From: Griffin, Tim (Contractor)
Sent: 31 January 2026 21:47
To: Harrison, Liz
Cc: Oliveira, Marta (Contractor); Dyer, Tim; Ellison, Mark
Subject: Re: Planning App Consultation Request Internal F/23/96629

Landscape Consultant

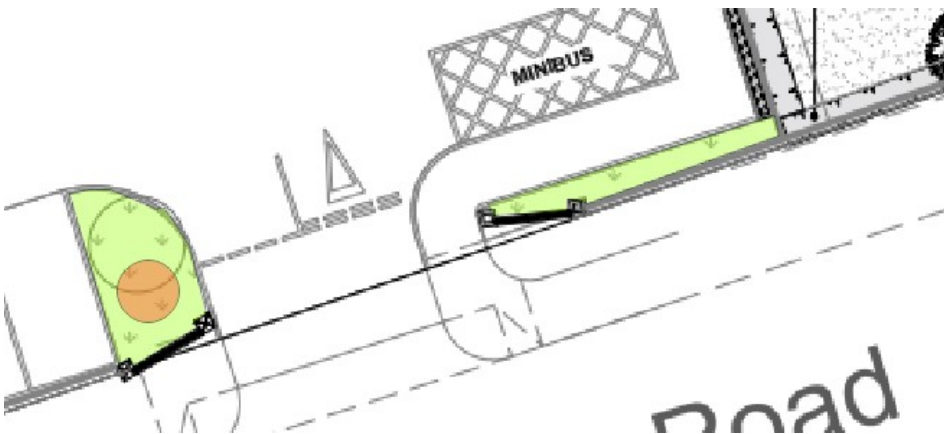
A/ The tree next to Bay 1 at the entrance - I understood that this was originally dropped due to comments from Highways that future growth of the tree would impede vehicles. The alternative fastigiate tree would have avoided this issue.

Apparently, drainage is now an issue! Although, when I look at the last iteration of the drainage layout I have seen, this does not appear to be a problem since a root barrier can be installed to prevent root damage.

If the applicant does still wish to omit this tree then instead the 2 plant beds below should be planted up with shrubs, including a slightly taller multi-stemmed specimen shrub on the LHS.

This is the main entrance to the site and so deserves some planting to improve the sense of arrivals.
